## INTERNATIONAL ASSOCIATION OF DRILLING CONTRACTORS

17 January 2014

International Association of Drilling Contractors is seeking a permanent variance from 29 CFR 1910.27 (b) (1) (i), (ii), (iii) and (c) (4) for all companies whose mast (derrick) ladders cannot meet the regulation.

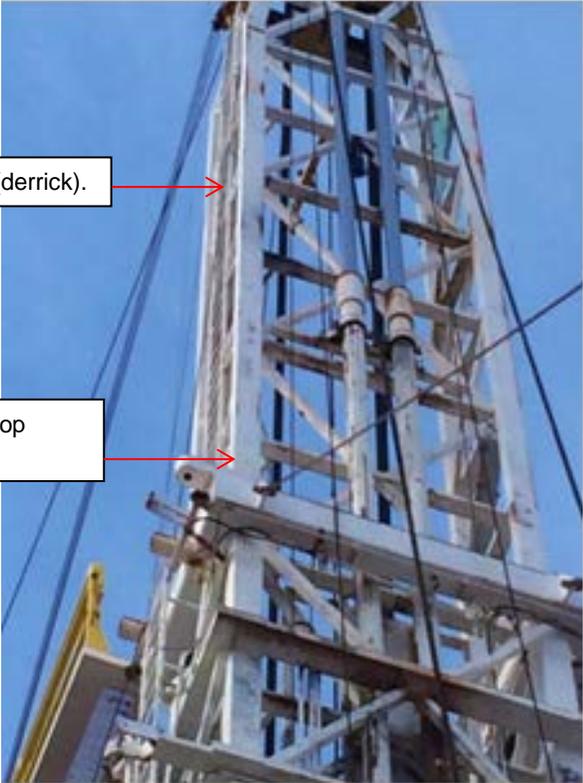
**See the following picture showing the close tolerance required between the upper and lower section of the mast (derrick).**

Note the ladder mounted to the mast (derrick).

Note the close tolerance between the top section and the bottom section.

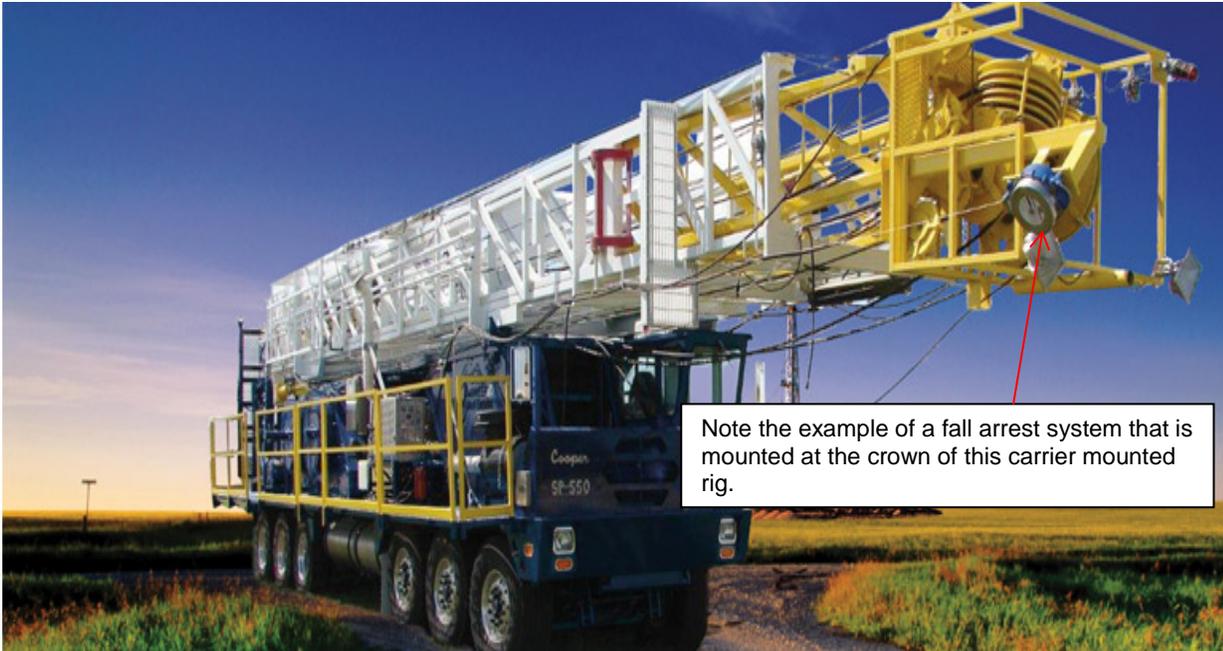
Note the fall arrest device that is attached to the crown structure of the mast (derrick).

Fall arrest system and notice to personnel that fall protection is required when climbing or working in the derrick.
